TECHNICAL REVIEW OF RISK DUE TO  
EXPANSION OF THE MORRIS OPERATION  
SPENT NUCLEAR FUEL STORAGE

ILLINOIS ATTORNEY GENERAL

MHB TECHNICAL ASSOCIATES  
366 CALIFORNIA AVENUE  
PALO ALTO, CALIFORNIA 94306

FEBRUARY 1979

FIGURE 3-2  
MORRIS OPERATION FACILITIES

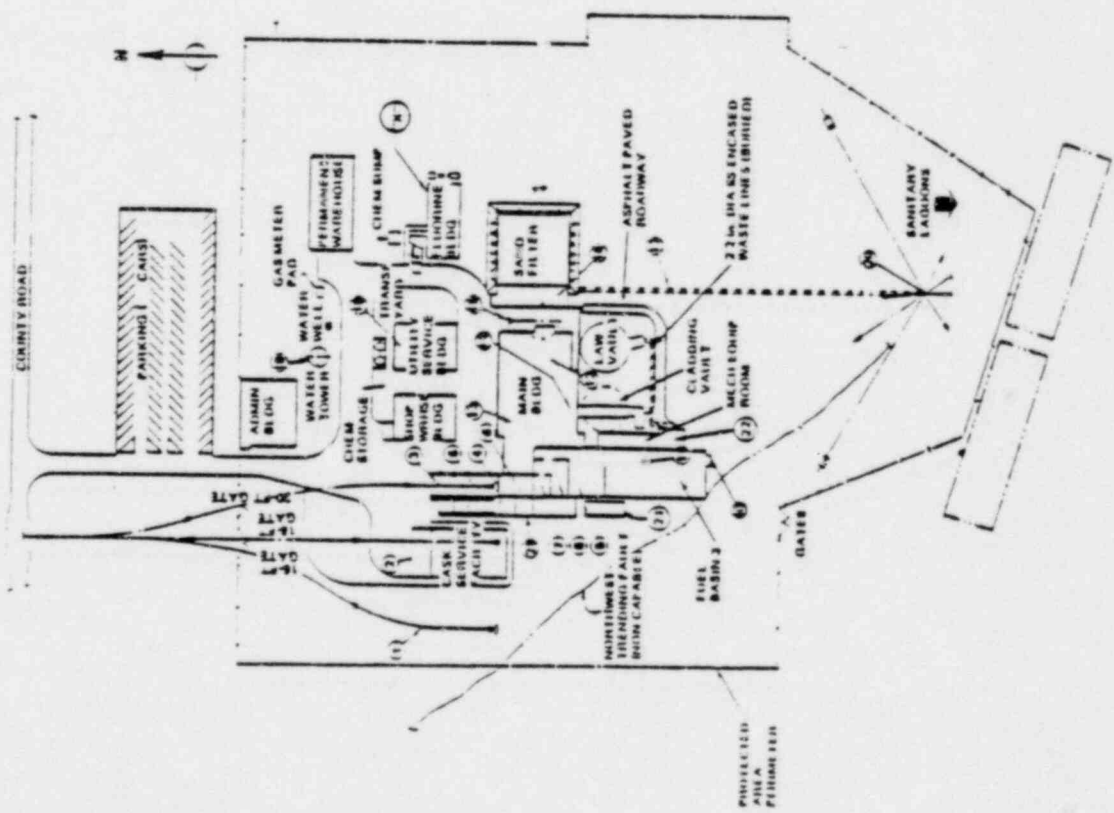
There are two stainless steel encased pipes which appear to run from the LAW vault to the basin water clean-up system and the cladding vault (see Figure 3-2). The design and protection of these pipes is not described in the CSAR, but they provide a potential leakage path during transfer to and from the LAW vault. Another area that is not well enough described in the CSAR to assess its importance is the security aspects of the LAW vault access hatches.

The pipe which carries the flow between the LAW vault and the cladding vault is another example (see Figure 3-2).

FIGURE 3-3

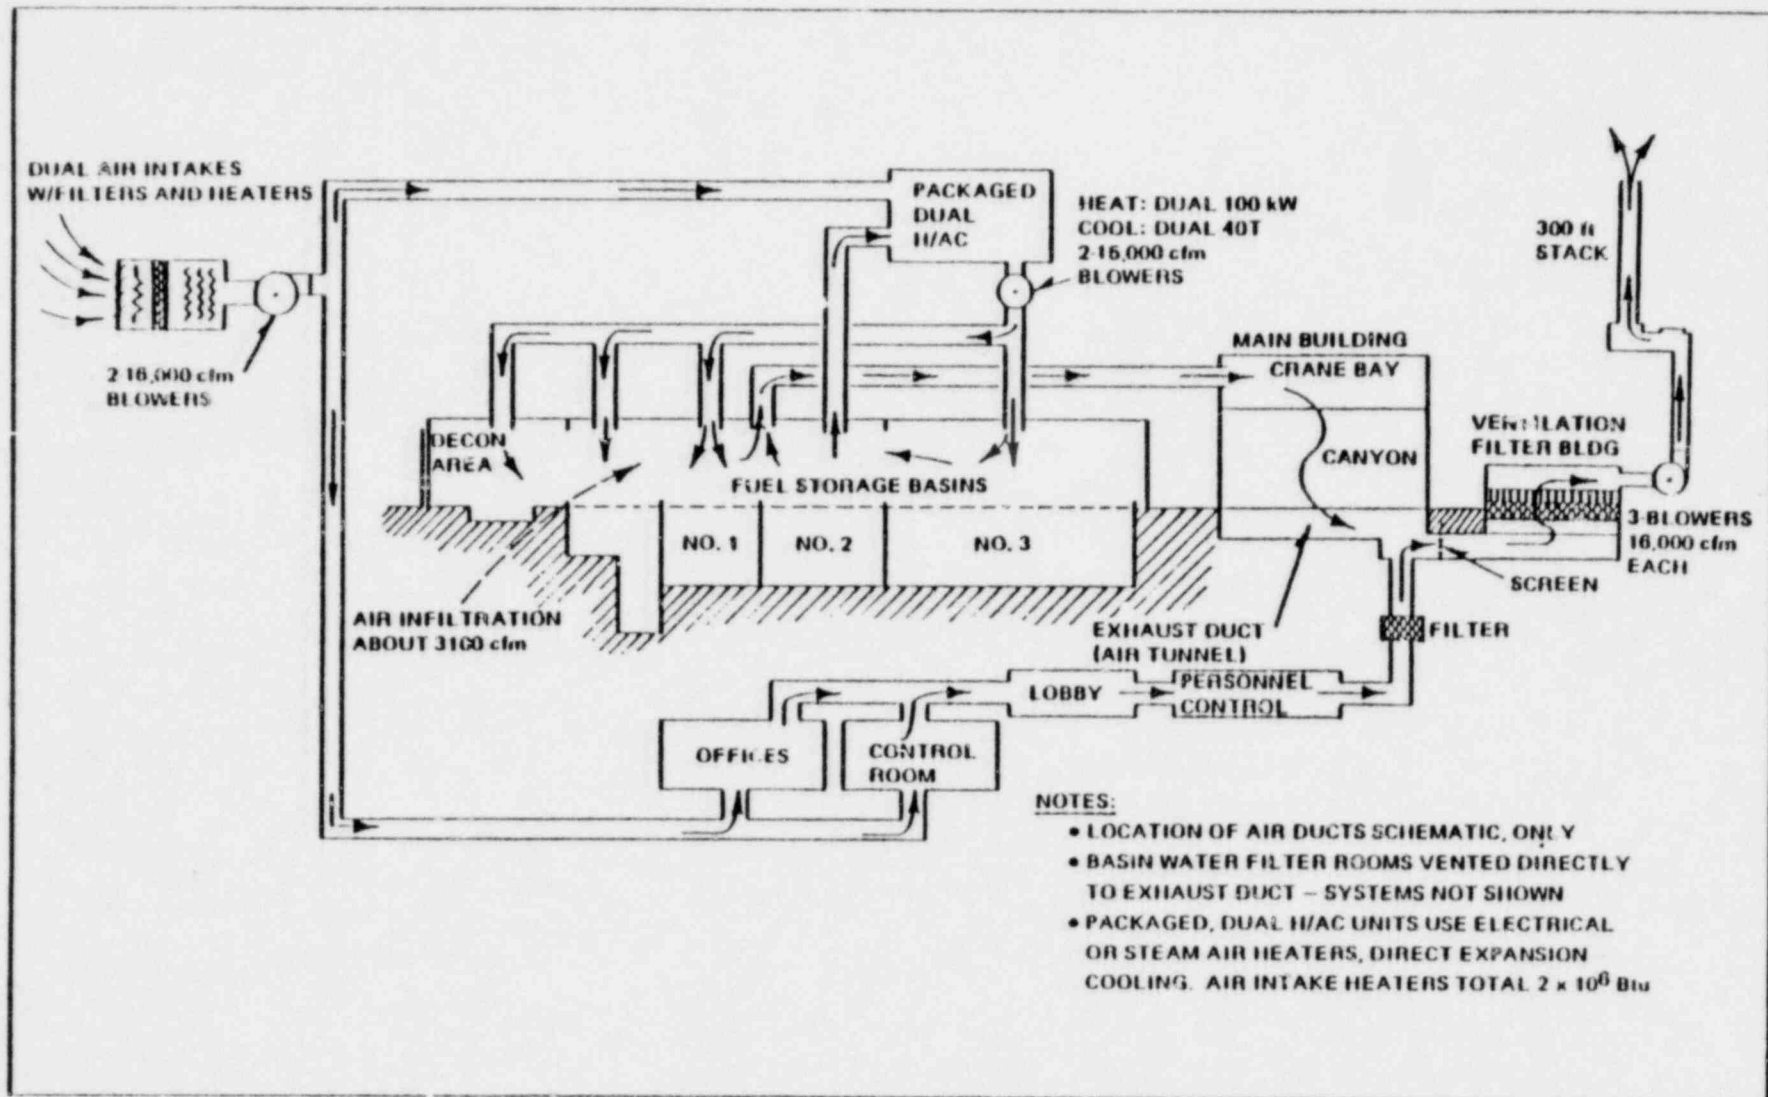
There are some features of the system which are insufficiently described in the CSAR to evaluate their impact on safety. For example, Figure 3-3, taken from the CSAR, shows the ventilation system recirculating a portion of the air through the heating/air conditioning unit. This could cause a build-up of radioactive contaminants in the unit as well as distributing airborne contaminants from one basin to another. In the event the screen or sand filter should clog, the blowers fail, or the stack ice up or fail, it could be possible for the blowers on the heating/air conditioning unit to force air backwards through the control room. The impact would be small because there are not many airborne contaminants during normal operation, but could be a complicating factor during an accident.

By far, the major airborne contaminant emitted from ruptured or leaking spent fuel will be krypton-85.<sup>(13)</sup> Krypton activity in spent fuel will range from 1000 to 10,000 curies/MTHM depending on the exposure and cooling time (24,000 MWD/MT with one year cooling is about 7000 Ci/MTHM), with 20 - 45% assumed to be in the plenum and released from the basin in the event of a rupture of the fuel cladding. Krypton (Kr) is a relatively inert noble gas and therefore very difficult to filter or extract from the ventilation stream. As a result, it is simply

FIGURE 3-4

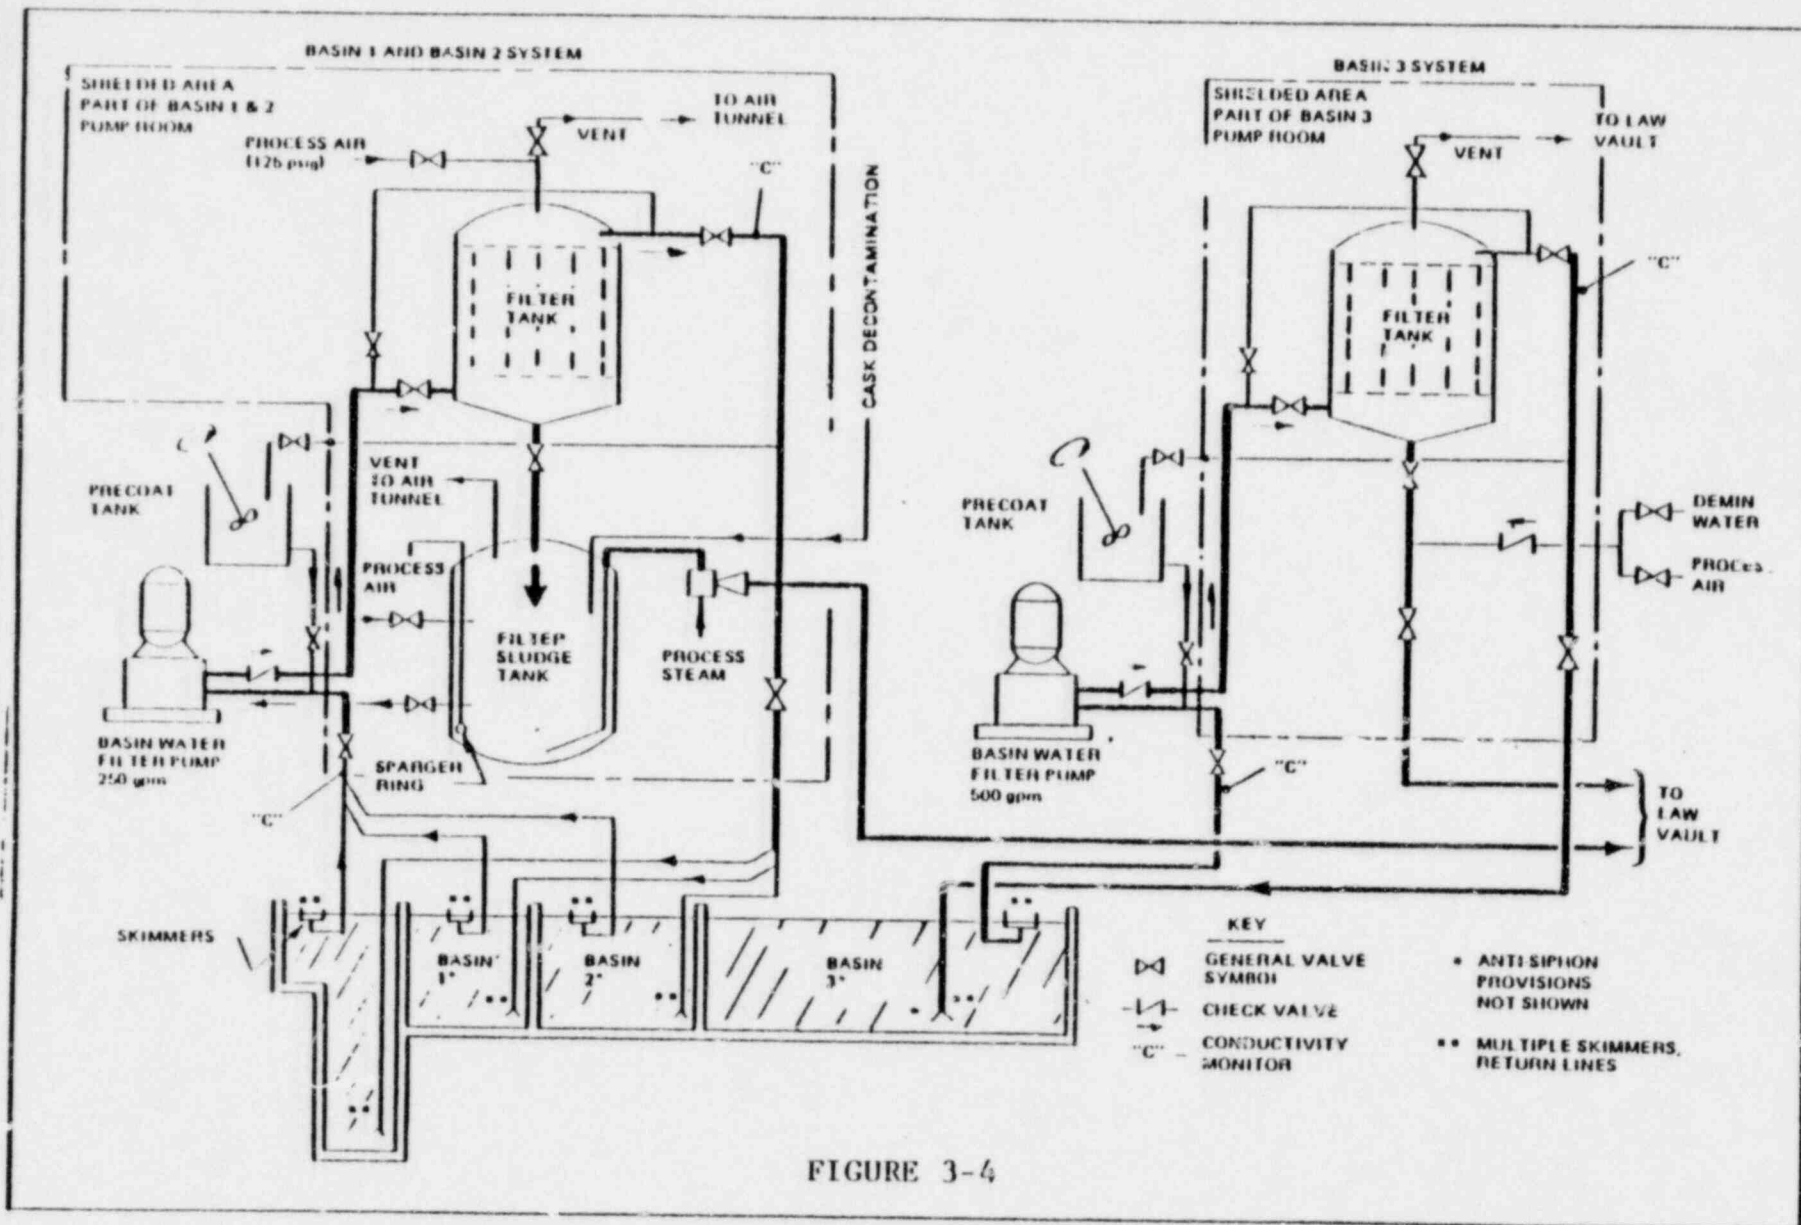
In the basin filter system shown in Figure 3-4, no redundancy or cross-connections appear to have been provided. This makes both systems (the original system and the new Basin 3 system) single-failure prone with only a loose coupling through the basin gates permitting the two systems to share the other's load. Such a condition would only be of concern, however, if the basin were heavily loaded with high exposure, short-cooling-period fuel and even in this situation, only if the cooling cannot be restored in a reasonable period of time (probably several days).

FIGURE 3-5

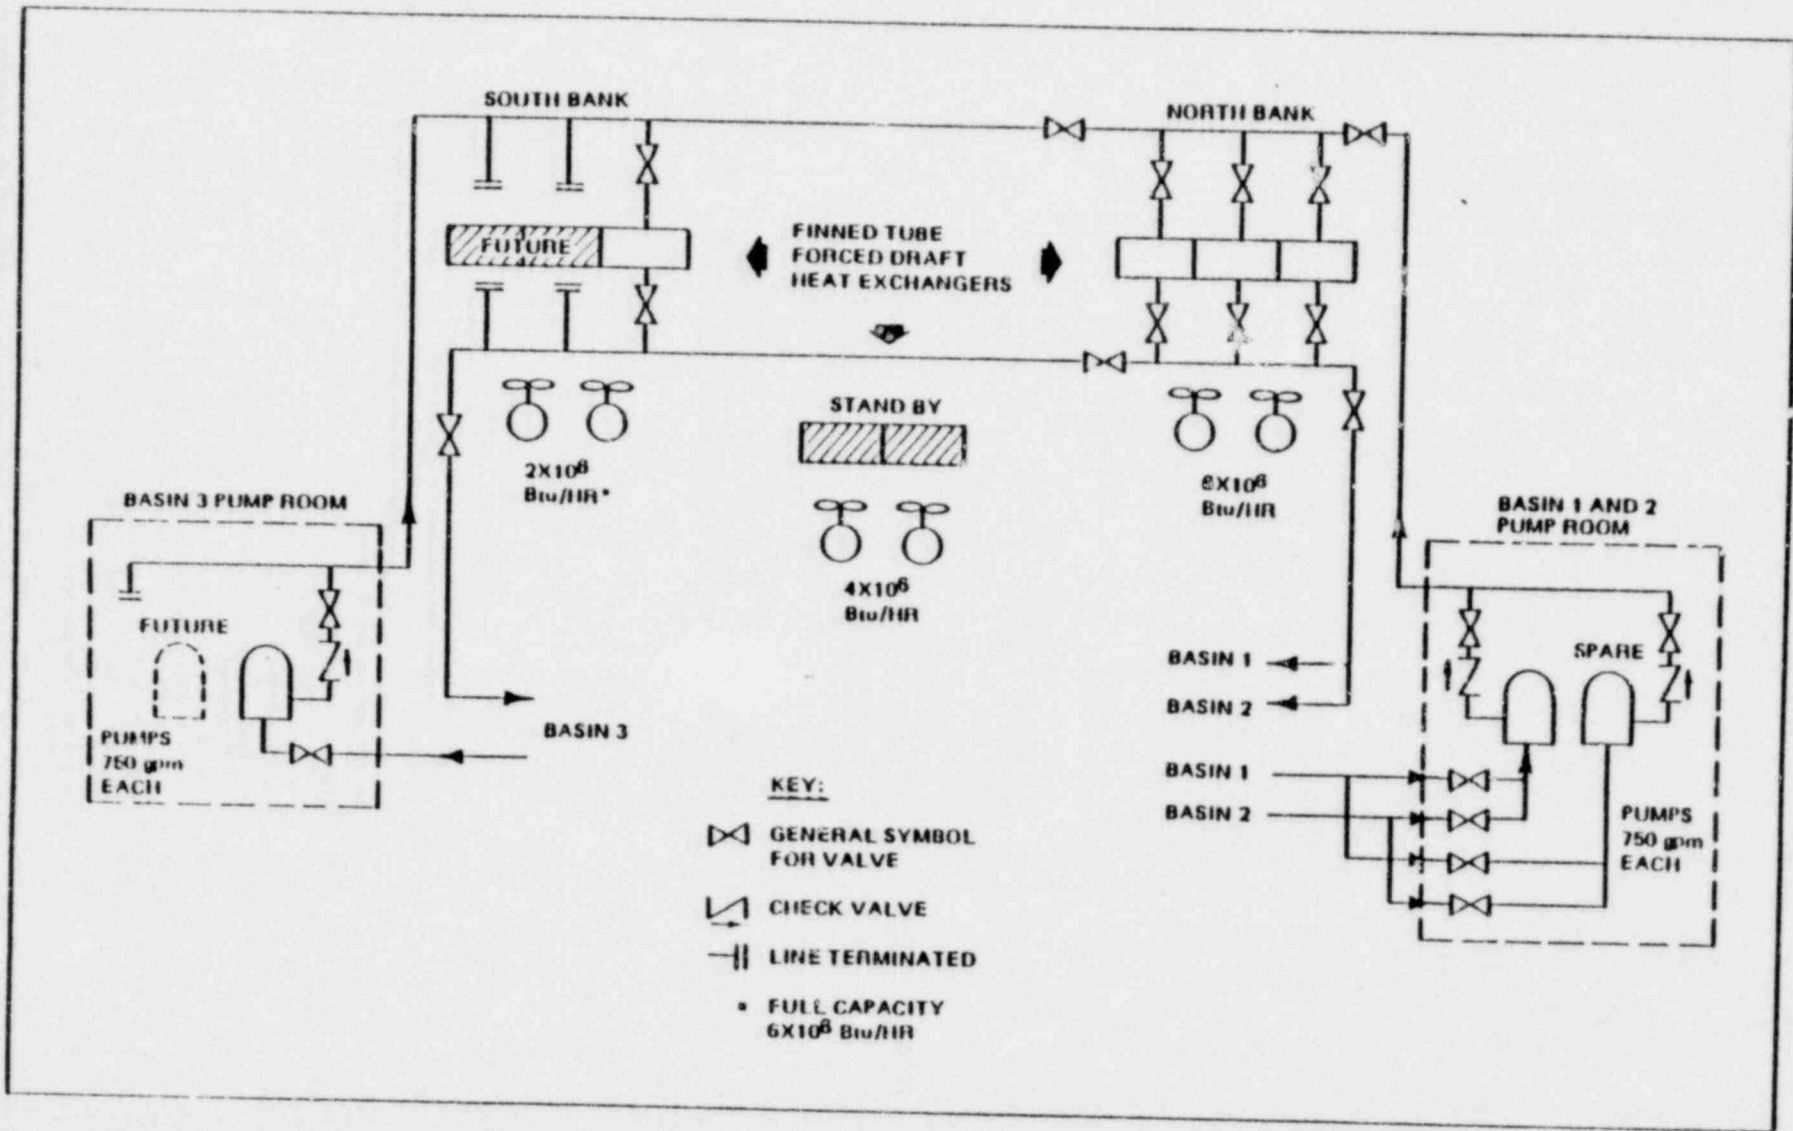
For the Basin Water Cooling System shown in Figure 3-5, more consideration has been given to sharing of the two systems. However, in the new and existing systems there is no provision for precluding crud or contamination build-up in the individual components nor is there a shielded area for the equipment as was provided for the water filters (see Figure 3-4).
